Re: Sound Power Levels, Modification 4 of the Maules  
Creek coal mine approval, Application by Maules Creek  
mine to delete Condition 12(a)

## **2. Horseshoe shaped valley**

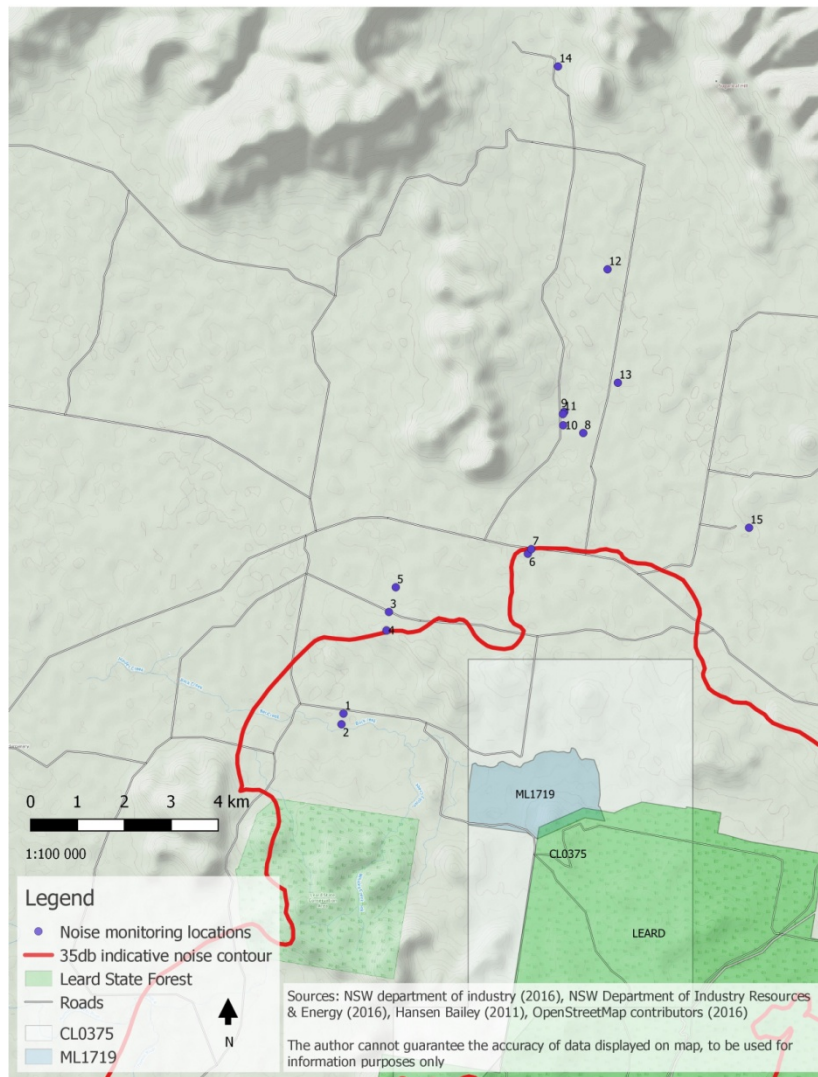
See map below, my property is number 14. At the northern end of Maules Creek valley. As you can see there is an unobstructed pathway for noise to travel from the mine in a northerly direction to my home. There are no land masses or vegetation to obstruct noise. Immediately to the west is the Turkey Ridge and to the east Nandewar Range, these sometimes have been heard to form an echoing effect.

I believe the catcher's mitt Geography is relevant and is a factor making the noise much worse than Whitehaven admitted.
